Access Compliance Report

Public Rights-of-Way

Intersection ID: N/A	Main Street: WAVERLY_WALK_AV	Cross Street: GOLF_LINKS_DR	Location: SE
ADA ID: AE88D9ACB609	Ramp Type: Perp	Initial Pass/Fail: Fail	Overall Compliance: No
		Severity Score: 12.5

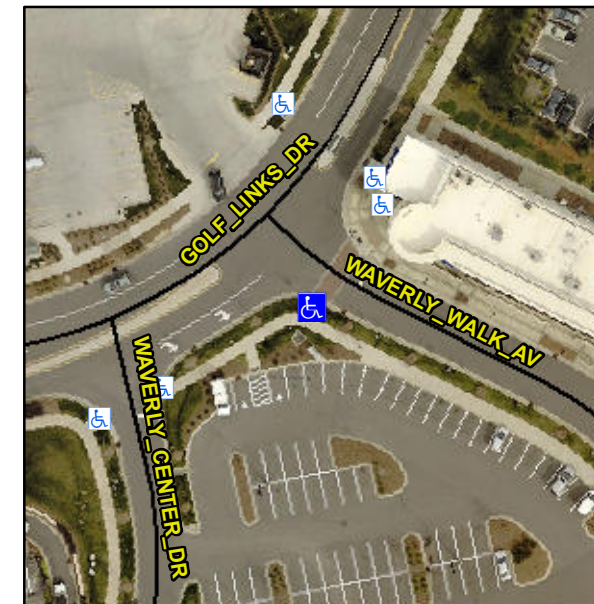
Not Found, R304.2.2

Compliance	Description	Data	Compliance	Description	Data
N/A	Ramp Length (in)	98.0	No	Ramp Slope (%)	8.6
Yes	Ramp Width (in)	59.0	Yes	Ramp XSlope (%)	1.7
N/A	Flare Type LT	N/A	N/A	Flare Type RT	N/A
N/A	Flare Slope LT (%)	N/A	N/A	Flare Slope RT (%)	N/A
N/A	Flare Traversable LT?	N/A	N/A	Flare Traversable RT?	N/A
N/A	Landing Length (in)	N/A	N/A	DWS Provided?	N/A
N/A	Landing Width (in)	N/A	N/A	DWS Contrast?	N/A
N/A	Landing Slope (%)	N/A	N/A	DWS Length (in)	N/A
N/A	Landing X Slope (%)	N/A	N/A	DWS Full Width?	N/A
N/A	Landing Curb? (Y/N)	N/A	N/A	DWS Offset (in)	N/A
N/A	Shared Landing?	N/A			
N/A	Gutter Ponding?	N/A	N/A	Gutter Slope (%)	N/A
N/A	Gutter Lip Ht (in)	N/A	N/A	Gutter X Slope (%)	N/A
N/A	Painted X Walk1?	No	N/A	Painted X Walk2?	N/A
	X Walk 1 Direction	To NE		X Walk 2 Direction	N/A
N/A	X Walk 1 Width (in)	N/A	N/A	X Walk 2 Width (in)	N/A
	X Walk 1 Slope (%)	1.6		X Walk 2 Slope (%)	N/A
	X Walk 1 X Slope (%)	2.5		X Walk 2 X Slope (%)	N/A

Remove & Replace Entire Ramp.
